Office Action Summary	Application No. 10/688,750	Applicant(s) MOLLINGER ET AL.	
	Examiner Lindsay M. Maguire	Art Unit 3692

DETAILED ACTION

This Non-Final Office Action is in response to the application filed on October 17, 2003, the amendments filed on June 26, 2006, and the Request for Continued Examination filed on January 22, 2007.

FIG-12

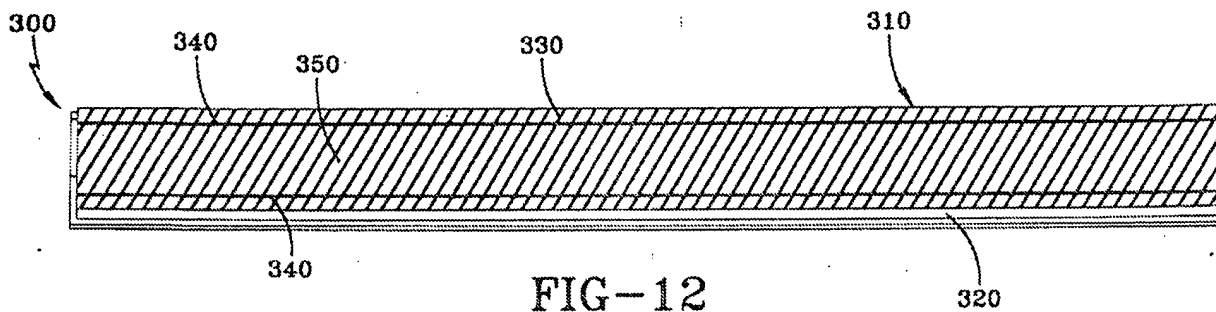
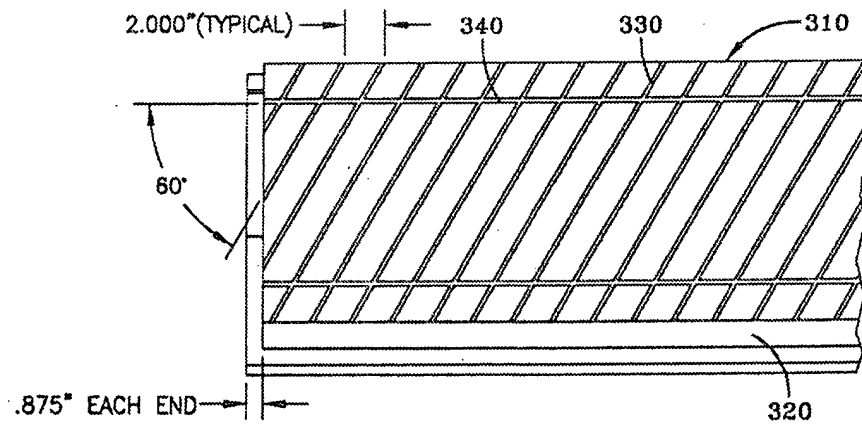
The drawings are objected to because writing in figures, other than the labeling of parts by numbers, is not permissible. Amended drawing sheets for Figures 12, 13, and 15 where all of the dimensions, titles, extraneous writing, etc. have been removed is required, or Applicant can cancel those three figures. Additionally it is improper for Figure 12 to contain more than one view. If applicant wishes for these three figures to be related or grouped together then it is advised that applicant name them "Figure 12A", "Figure 12B", and "Figure 12C".

The previously filed replacement drawing sheets filed on November 20, 2006 have not been entered since, the aforementioned drawing objections had not been corrected to meet the requirements as mentioned above. Applicant has not provided a corrected copy of Figures 12, 13, and 15 in this request for continued examination of the application. This requirement is therefore made **Final**.

Do Not
Enter
2/23/07
[Signature]
